Arboriculture Addendum
121 Pacific Rd Palm Beach

Prepared by: Geoffrey Ashton Arboriculture AQF Level 5

1 Addendum Recommendations

In response to address a Northern Beaches Council response letter dated 23rd February 2022 in relation to development application No. DA2021/2364 at 121 Pacific Rd Palm Beach NSW¹.

4 Appendix A Tree Protection Plan Diagram

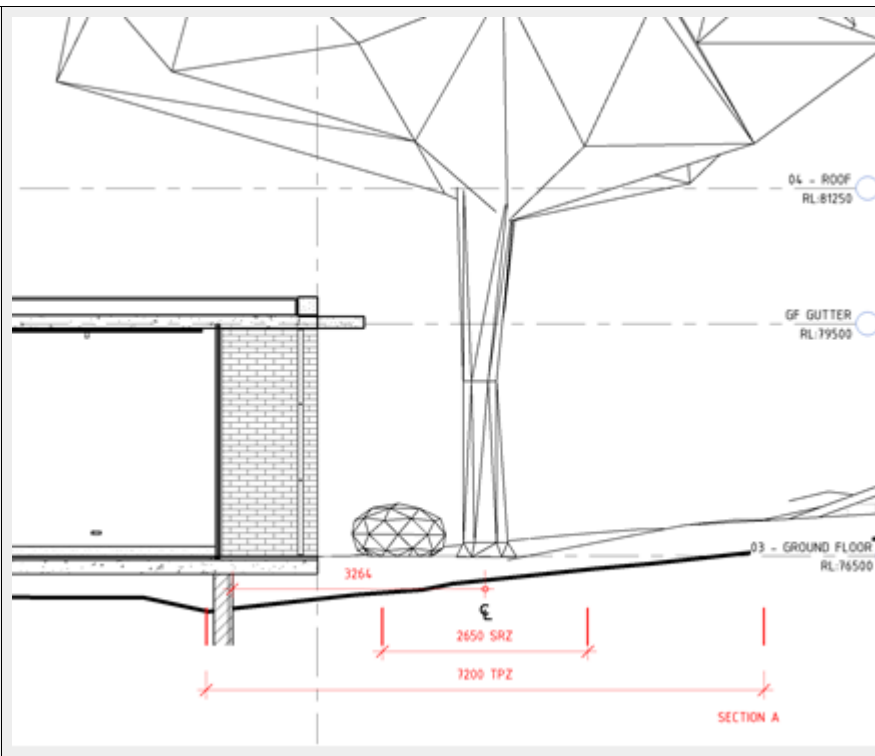
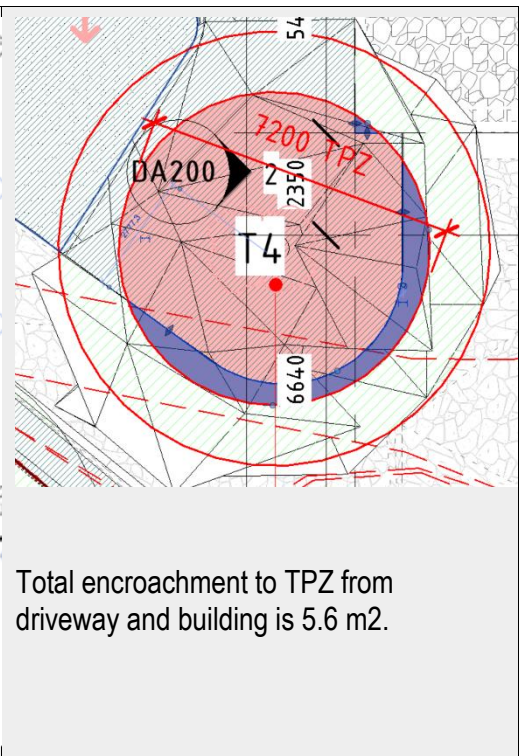
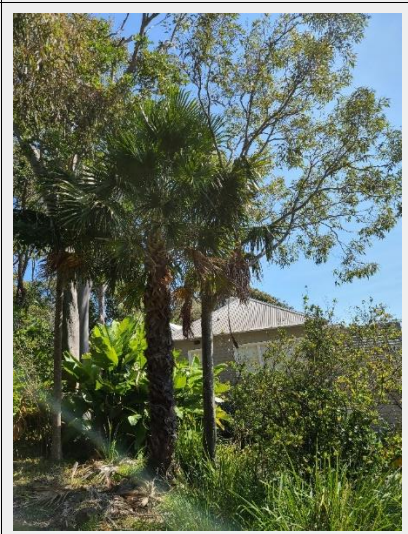
This addendum reiterates the recommendation to remove Tree 2 as the subject tree has significant damage to the main stem on the northern side. The tree is self-optimised however potential encroachments may reduce the trees growth optimisation and result in an increased risk of failure. The area around the tree will have an increased occupation once the development is complete and a replacement planting is the recommended long-term management for the site. It is additionally noted that the tree is likely to be exempt under the RMS 10/50 rule due to the distance from the current dwelling and could be removed prior to this application.

Tree 3 is on the boundary and believed to be in the neighbouring property to the south. A letter of consent from the owning body dated 28th February 2022² gives permission for Tree 3's removal. This tree is an exempt species and Northern Beaches Council has deemed the tree does not require consent within the Northern Beaches Council response letter dated 23rd February 2022¹.

Northern Beaches Council requested Tree 4 be retained and further discussions and information provided show minor encroachments on the subject tree within the current plan. There is a cantilevered slab, and it is understood the cantilevered slab must be above the existing root systems to maintain the minimal impact. Measurements provided which are inserted into the Appendix C Site Images show there is a total encroachment to TPZ from driveway and building of 5.6m² which is an encroachment of 3.44 % of the formulated Tree Protection Zone. Protection measures are to be implemented throughout the development process to reduce impacts on the subject tree.

The removal of a council verge tree (Tree 14) was recommended and is still recommend as the tree is in poor health. However, the removal of the tree is not required to allow for the development to proceed. The subject tree is insignificant within the streetscape and a replacement planting would be the best long-term management for the site.

Neighbouring Trees 20 and 21 are less significant and in close proximity to the proposed building. The subject trees are in the property to the north and are recommended for removal. A letter of consent from the owning body dated 3rd March 2022³ provides permission for the removal of these trees. This letter should suffice council's request for owning bodies consent prior to the approval of the proposed plans as outlined in the Northern Beaches Council response letter dated 23rd February 2022¹.
